REQUEST FOR QUALIFICATIONS - ADDENDUM 1

MAMMOTH COMMUNITY WATER DISTRICT

Seismic and Structural Risk Analysis Assessment Services

ATTACHMENT 3 – MAPS OF MCWD WATER AND SEWER SYSTEMS

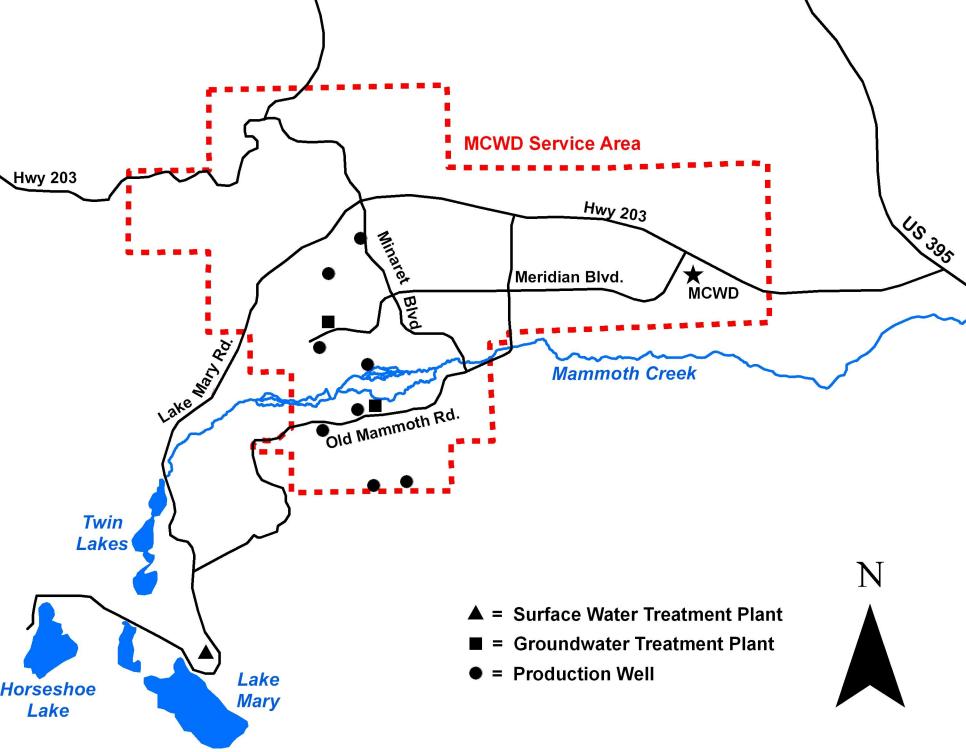
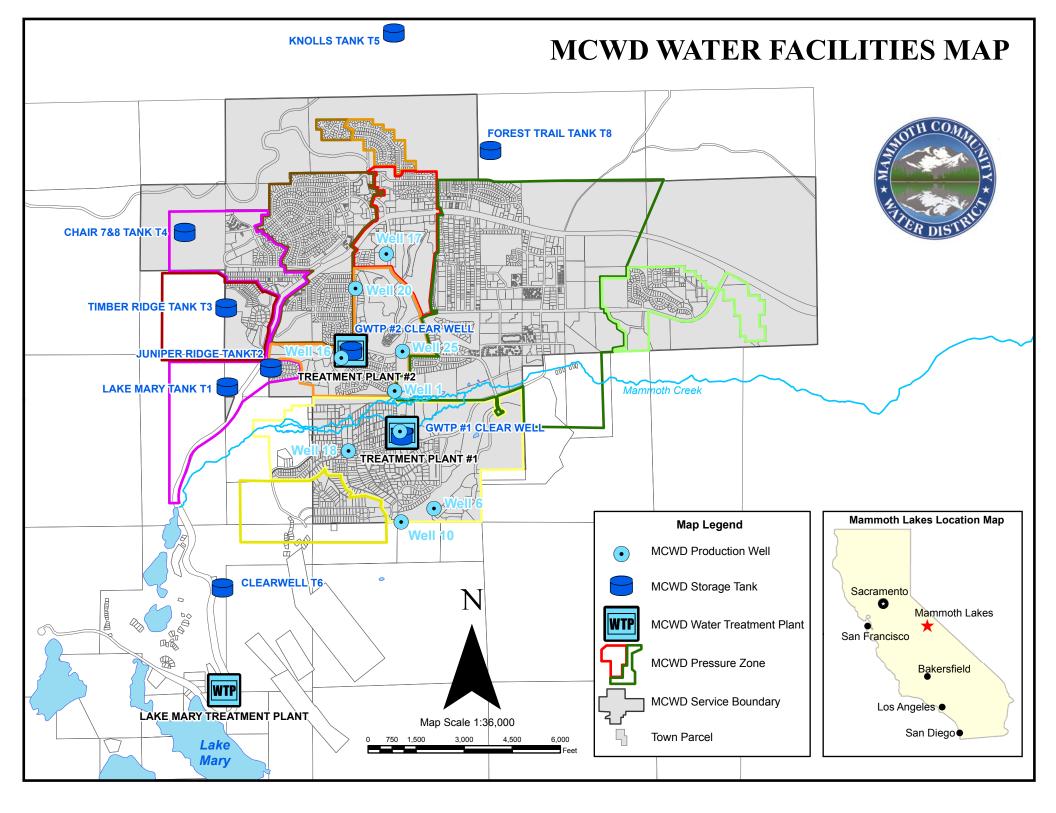
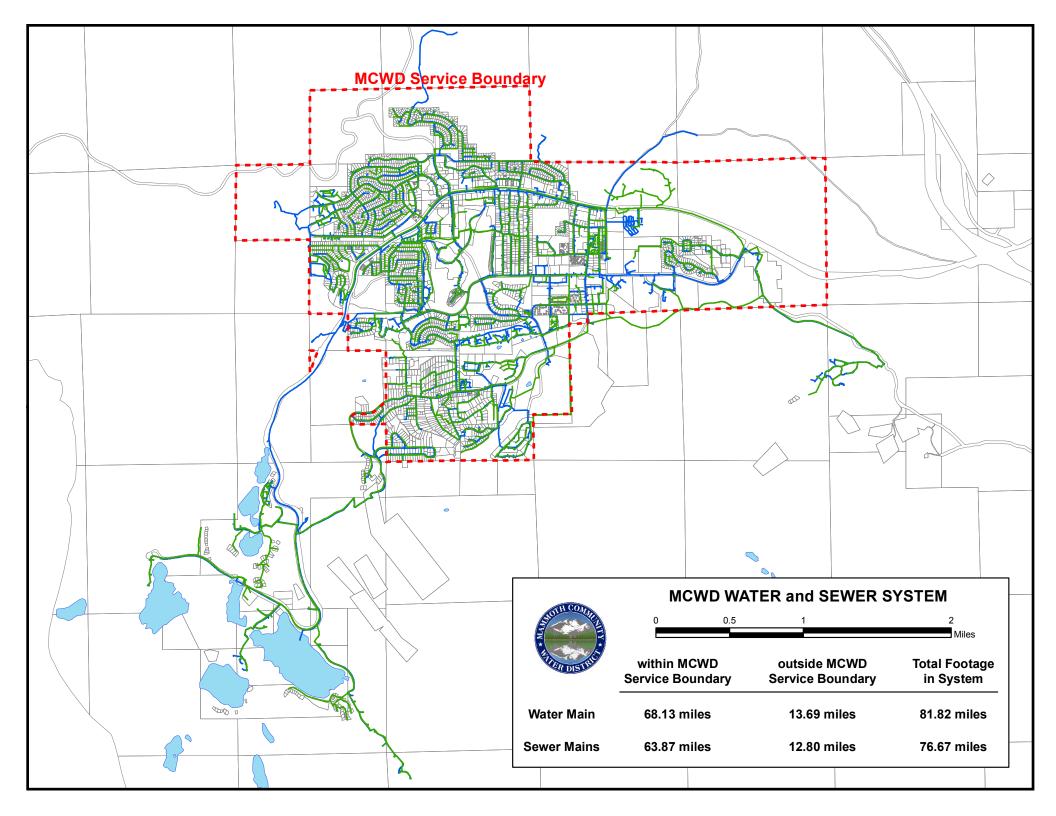
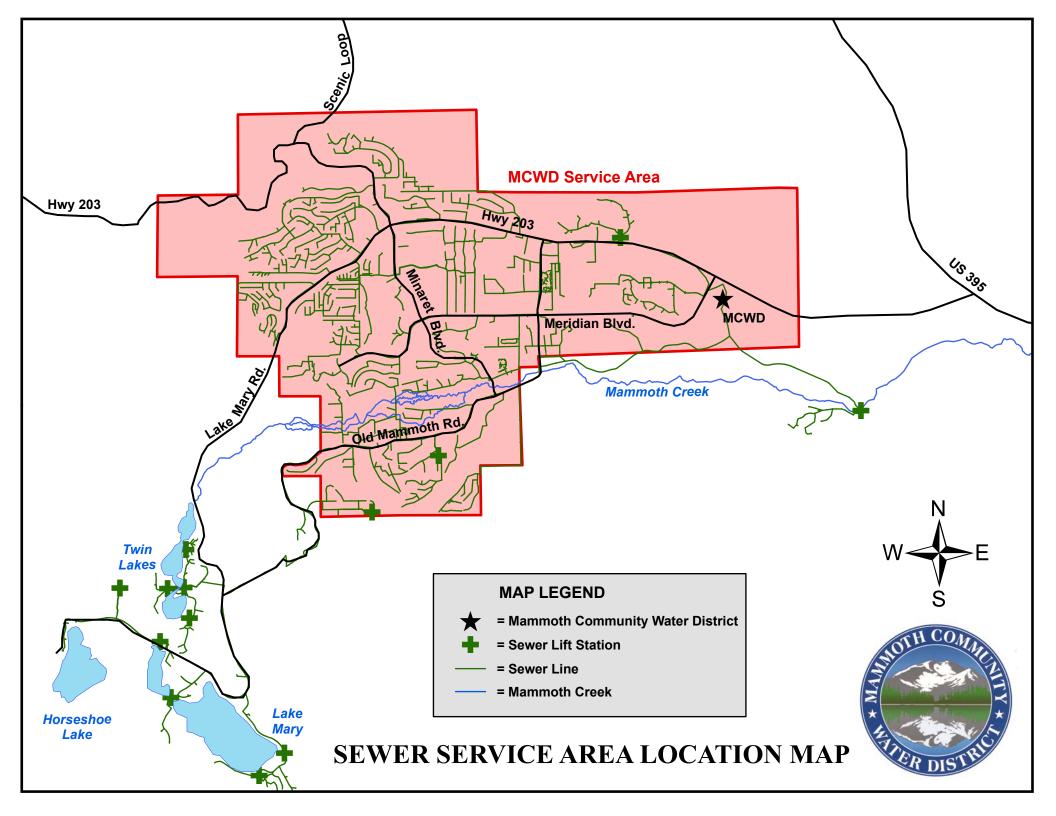
- 5. QuestionCan you provide layout diagrams for the water and sewer distribution networks?AnswerMaps of MCWD's water and sewer systems are provided in Attachment 3.

ATTACHMENT 4 - LABELLED MAP OF MCWD WASTEWATER TREATMENT PLANT AND NEARBY BUILDINGS

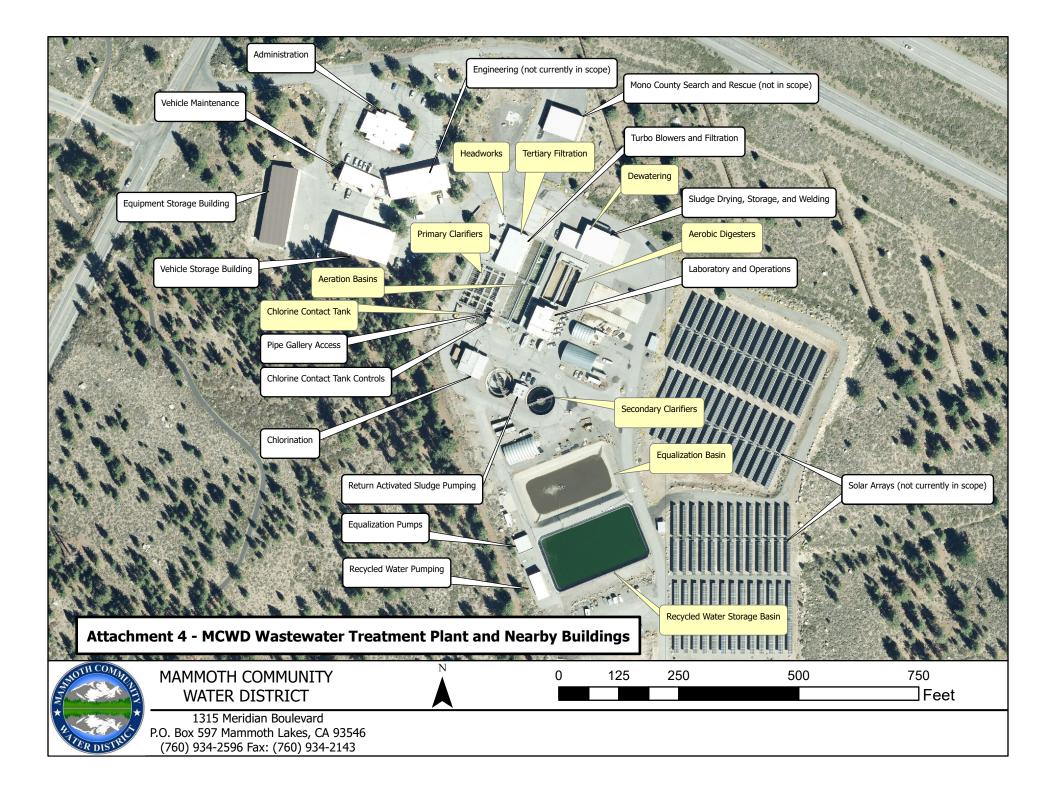
- 6. Question
 Can you provide a labelled map of the wastewater treatment plant facilities and a process flow diagram?
 Answer
 A labelled map of the MCWD wastewater treatment plant and nearby buildings is provided in **Attachment 4**.

ATTACHMENT 5 – PHOTOS OF DAMAGE AT TANK T8 (FOREST TRAIL) AND THE EQUALIZATION PUMPING BUILDING

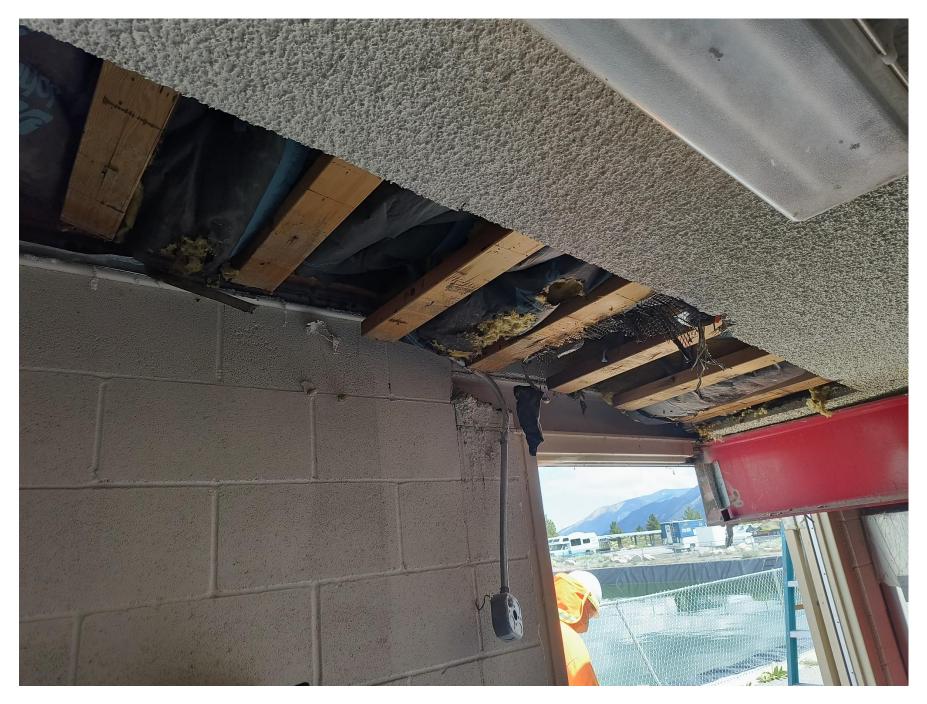
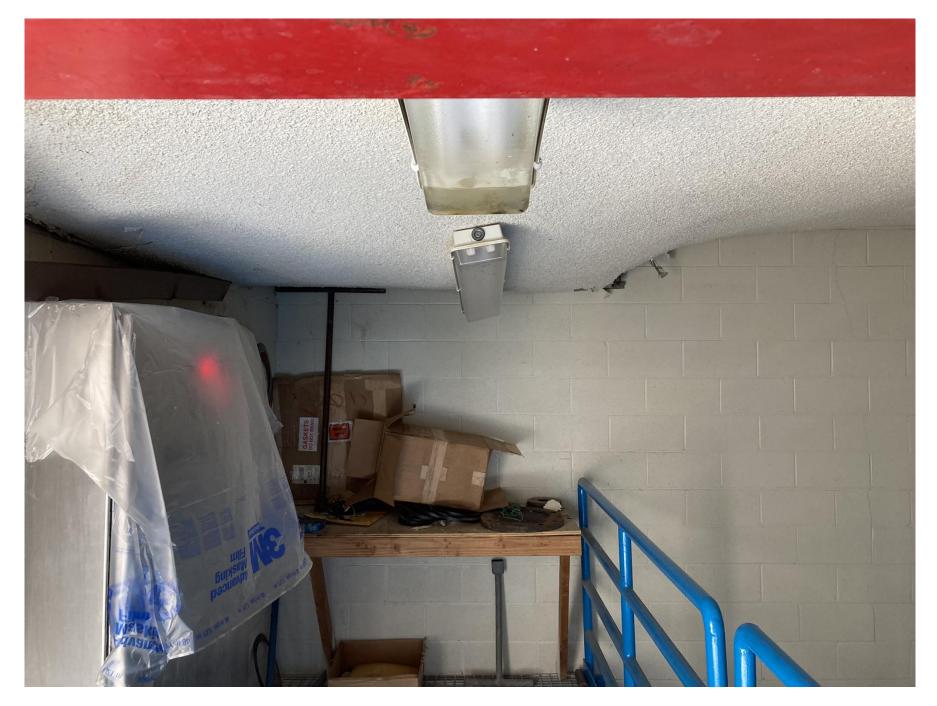
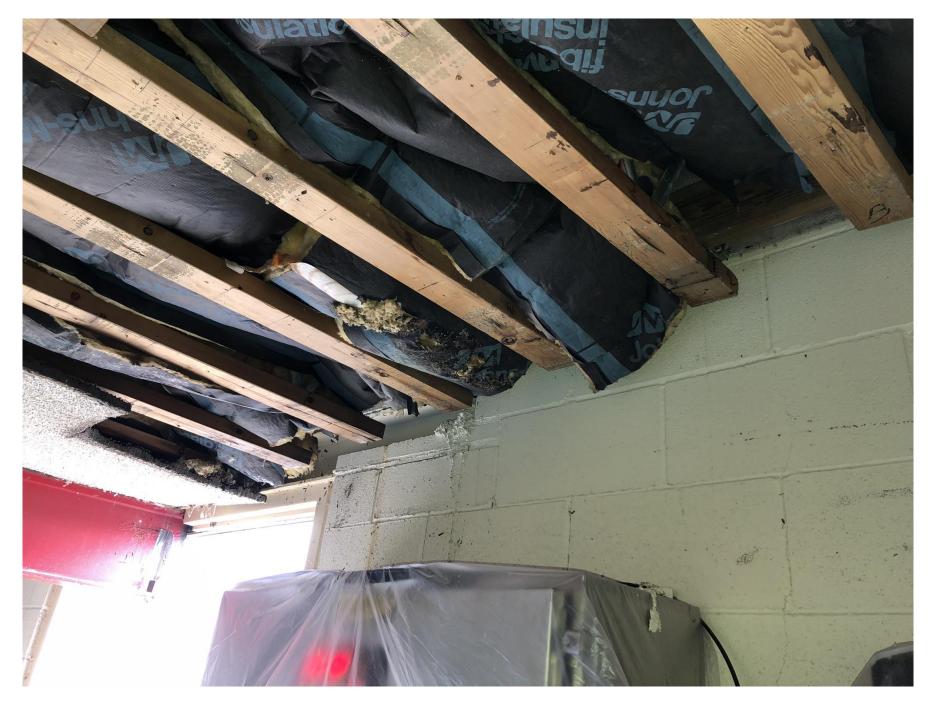
7. Question Can you provide photos of the tank and building that failed due to snow load in 2023?

Answer Photos of Tank T8 (Forest Trail) and the Equalization Pumping Building are provided in **Attachment 5**. T8 was replaced with a welded steel tank and the Equalization Pumping Building trusses and roof were replaced with wooden trusses and a new roof and membrane in the summer-fall of 2023.
